**Economic Commission for Europe****Inland Transport Committee****World Forum for Harmonization of Vehicle Regulations****Working Party on Passive Safety****Fifty-fifth session**

**Global technical regulation****No. 9 (Pedestrian safety) – Proposal for amendments to Phase 1 and draft Phase 2****Proposal for amendment to Phase 1 to global technical regulation No. 9 (Pedestrian safety)****Submitted by the expert from the European Commission\***

"Figure 6A

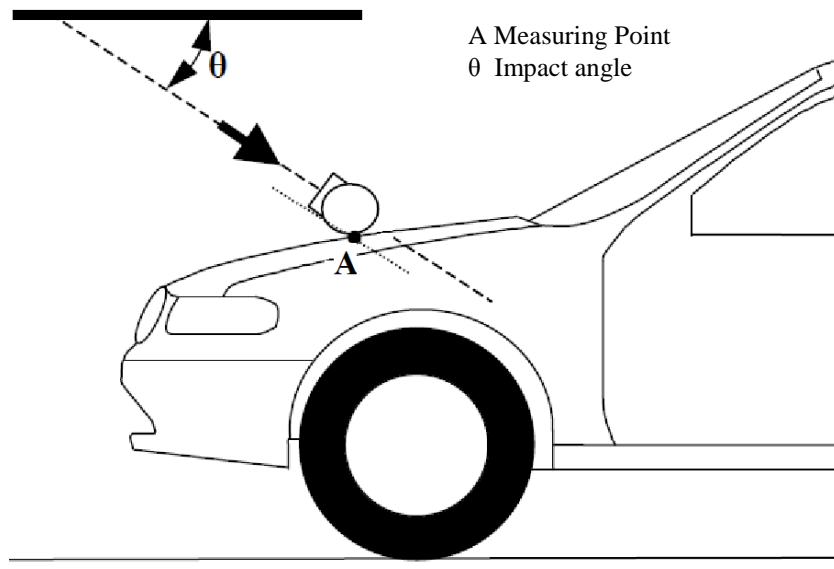
**3.20.1. "Measuring point" for the headform test means a point on the vehicle's outer surface selected for assessment. The measuring point is where the headform's profile contacts the vehicle's outer surface cross section in a vertical longitudinal plane through the center of gravity of the headform (see Figure 6A).**

Figure 6, shall be deleted

Insert new Figures 6A and 6B, to read:

**Measuring point in the vertical longitudinal plane through the centre of the headform impactor (see paragraph 3.20.1.)<sup>2</sup>**

<sup>2</sup> Note: due to the spatial geometry of the bonnet top, the first contact may not occur in the same vertical longitudinal or transverse plane which contains measuring point A.

Figure 6B  
**Measuring point in the vertical longitudinal plane through the central axis of the legform impactor (see paragraph 3.20.2.)**

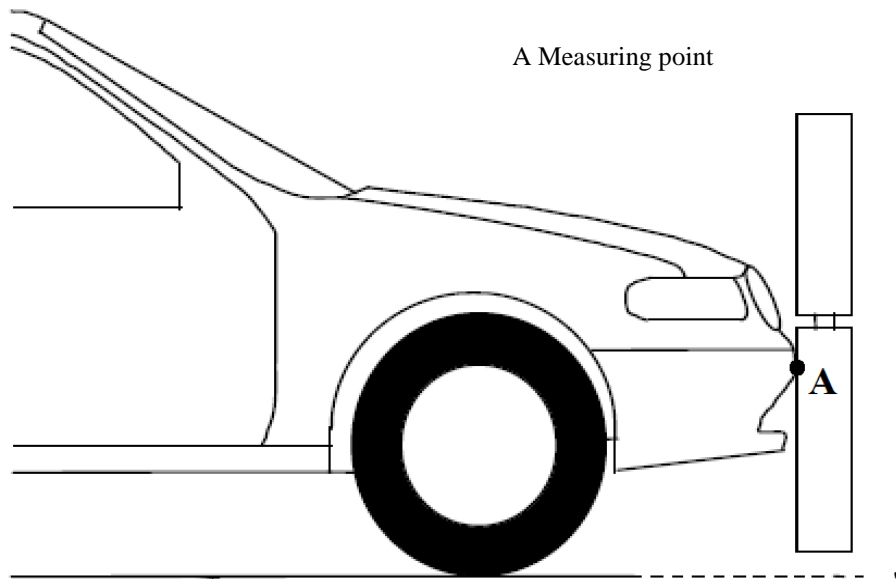
**3.20.2. "Measuring point" for the lower legform to bumper test and the upper legform to bumper test is located in the vertical longitudinal plane through the central axis of the impactor (see Figure 6B)."**

"Figure 11

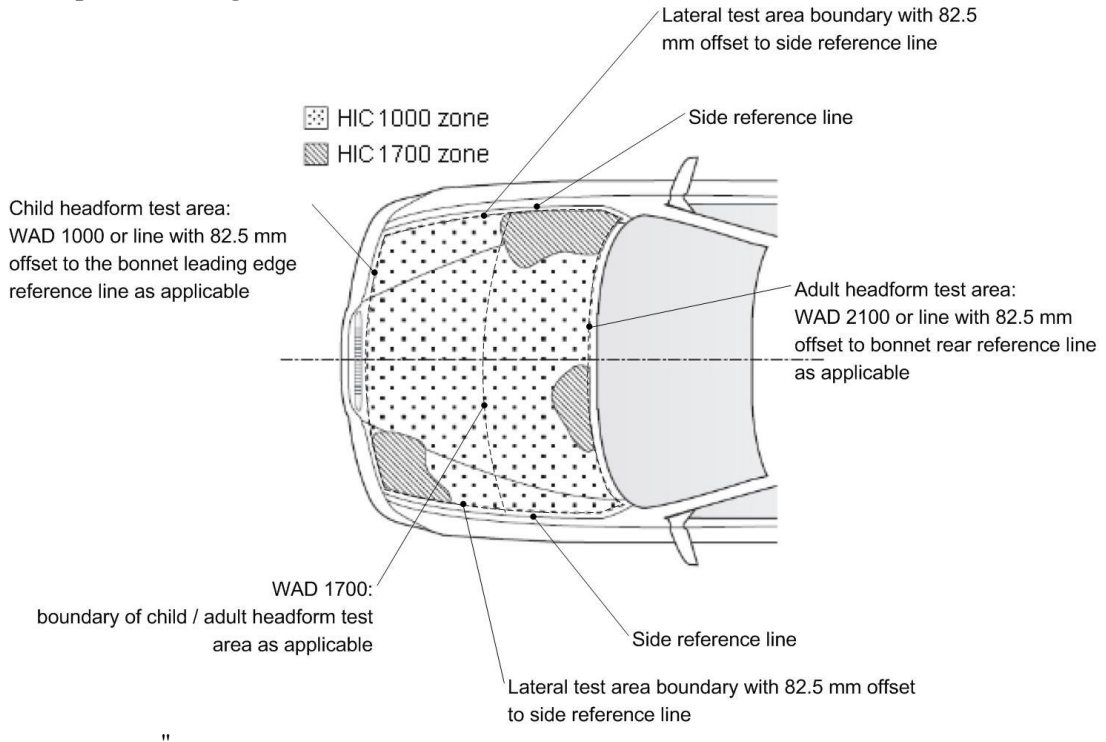
"5.2.4.1. The manufacturer shall identify the zones of the bonnet top **test area** where the HIC must not exceed 1,000 (HIC1000 Zone) or 1,700 (HIC1700 Zone) (see Figure 11)."

Figure 11(former), shall be deleted

Insert new Figure 11, to read:

**Example of marking of HIC1000 zone and HIC1700 zone**
